Waterloo Metro Quarter Over Station Development – Northern Precinct

State Significant Development Assessment
SSD 10440

Published by the NSW Department of Planning, Industry and Environment

Figure 24 | Left – south-east view artist's impression of height at lodgement of the SSD, prior to DRP feedback **Right** – height lodged with RtS, after DRP feedback (source: Applicant's RtS)

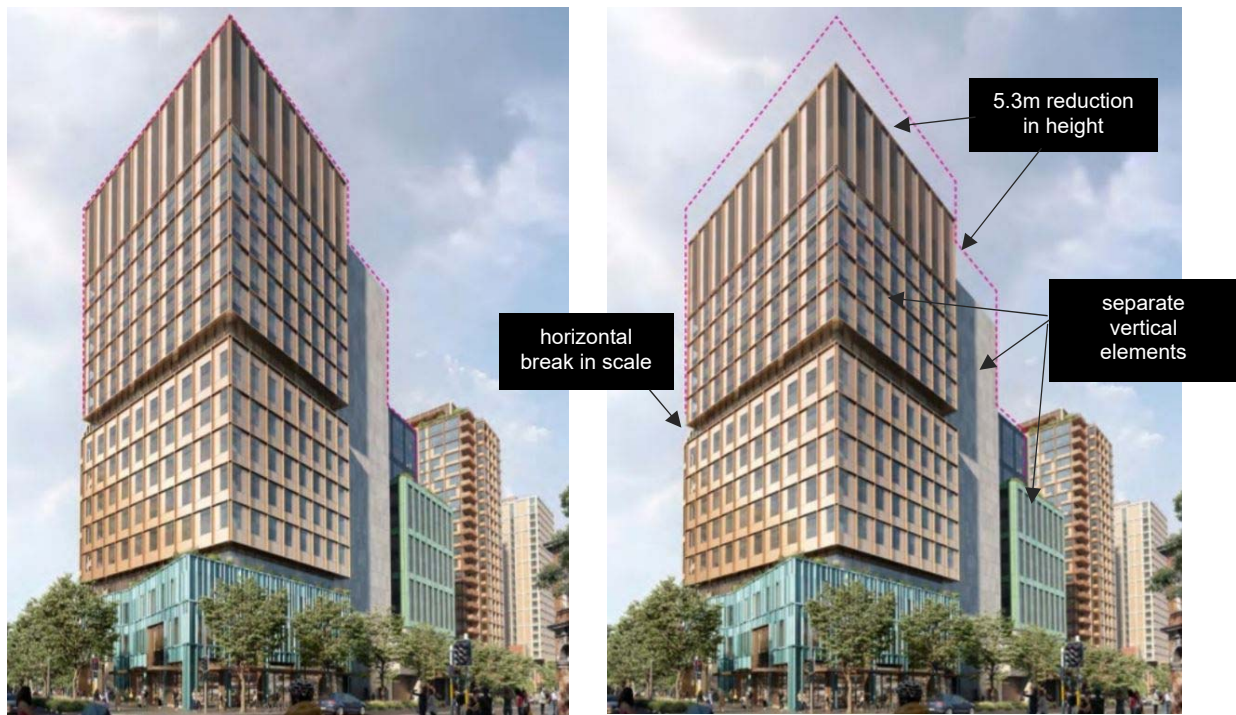
The Applicant argues that the scale and proportion of the proposed building is appropriate because the building includes clear horizontal breaks to reduce the visual perception of the building's height when viewed from the corner of Botany Road and Raglan Street. The Applicant also argues the bulk of the proposed building is further broken down into two distinctive vertical forms at 27m and 34m wide respectively along Botany Road. These vertical forms are similar in width and compatible with the proposed buildings in the Central Precinct and Southern Precinct as viewed along Botany Road (**Figure 24**).

The DRP supported the Applicant's RtS amendments, including the reduction in height and the associated alteration to the height proportions of the building above and below the Level 9 recess.

Figure 26 | Overshadowing analysis on Alexandria Park showing impact caused from Central and Southern Precinct buildings at 9:30am in midwinter (Source: Applicant's EIS)

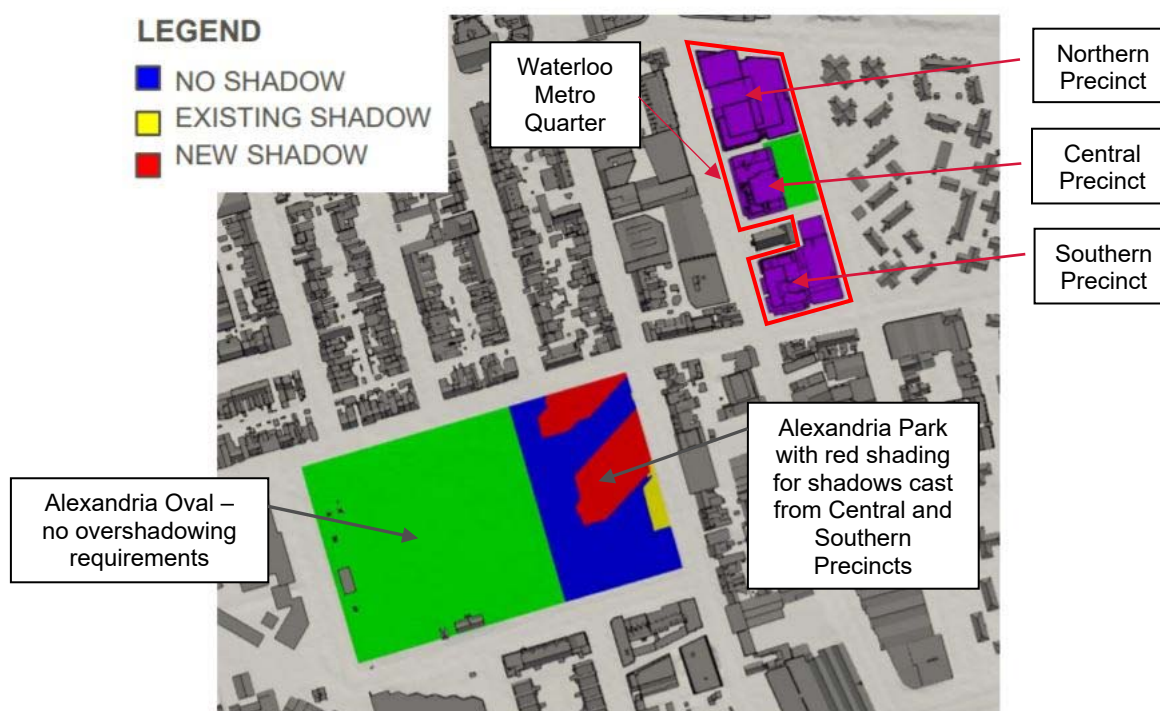
Public submissions raised concerns with overshadowing impacts to Alexandria Park.

The proposal is supported by solar analysis to identify the potential overshadowing impacts of the proposed buildings to Alexandria Park. The submitted shadow diagrams identified that the proposed building within the Northern Precinct would not overshadow Alexandria Park. The overshadowing impacts on Alexandria Park are limited to those cast by the proposed buildings in the Central and Southern Precincts before 10am (**Figure 26**).

The Department engaged an independent solar access consultant to review the Applicant's shadow analysis. The Department's consultant accepted the Applicant's analysis to be accurate and commented that the modelling provided sufficient detail to assess the proposal.

Figure 28 | Solar access to Alexandria Park Heritage Conservation Area to the west at 10am
(Source: Applicant's EIS)

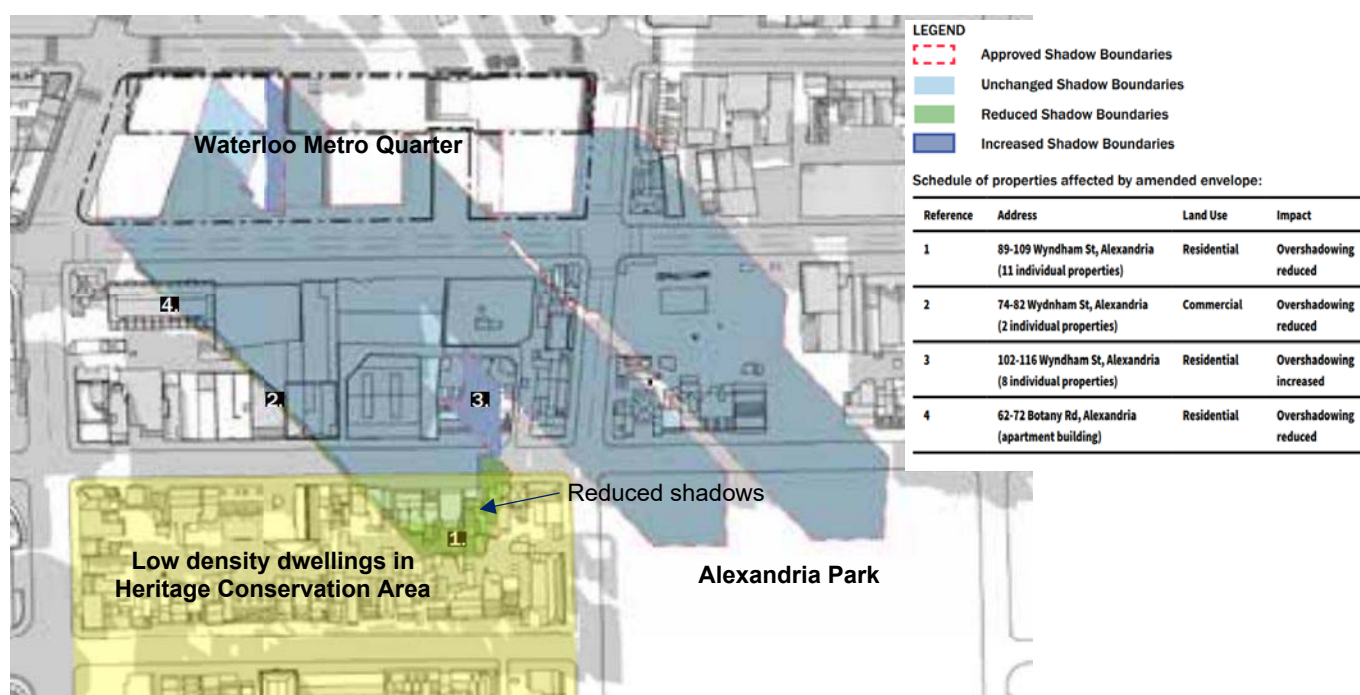
Council acknowledged improvements to solar access to residential properties in the Heritage Conservation Area due to the reduced height of the Northern Precinct compared to the original Concept Approval (**Figure 28**).

However, Council, raised concern that the Applicant's solar analysis did not demonstrate specific criteria in the Design Guidelines had been met with respect to analysis of all living rooms windows and did not adequately consider impacts to residential properties to the south.

In response, the Applicant submitted additional overshadowing analysis of private residential properties to the west (**Figure 28**). The analysis showed that all affected properties are able to maintain at least two hours solar access between 9am and 3pm in midwinter. Whilst some properties in the Alexandria Park Conservation Area show reduced shadow impact compared to the Concept Approval, other properties in the block immediately west of the Waterloo Metro Quarter have marginally increased shadow impact whilst maintaining at least two hours.

Figure 31 | Proposed ground floor showing extent of active street frontage (Source: RtS)

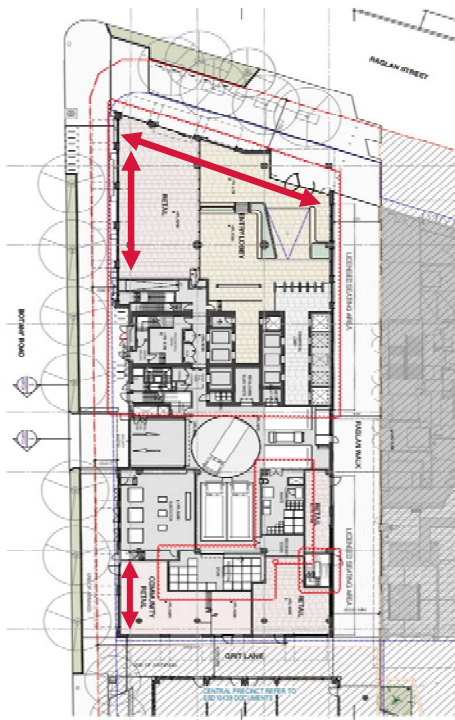
The proposal includes ground floor frontage along Botany Road and Ragan Street. However, the corner of Raglan Street and Cope Street is to be occupied by the approved Metro station structure under CSSI 7400, with the proposed office building from Level 4 above (**Figure 31**).

Council advised that the proposal does not comply with Clause 7.27 of the Sydney LEP 2012 in relation to providing an active street frontage to Botany Road (**Figure 32**) and the Applicant should provide a statement under Clause 4.6 of the LEP in relation to the non-compliance.

In response, the Applicant lodged a request under Clause 4.6 of the Sydney LEP in relation to building services along the Botany Road frontage that are not excluded by Clause 7.27. The Applicant contends the proposal's non-compliance with Clause 7.27 –Active Frontage is acceptable because the street frontages have acceptable activation and the site also has the internal laneways for activation.
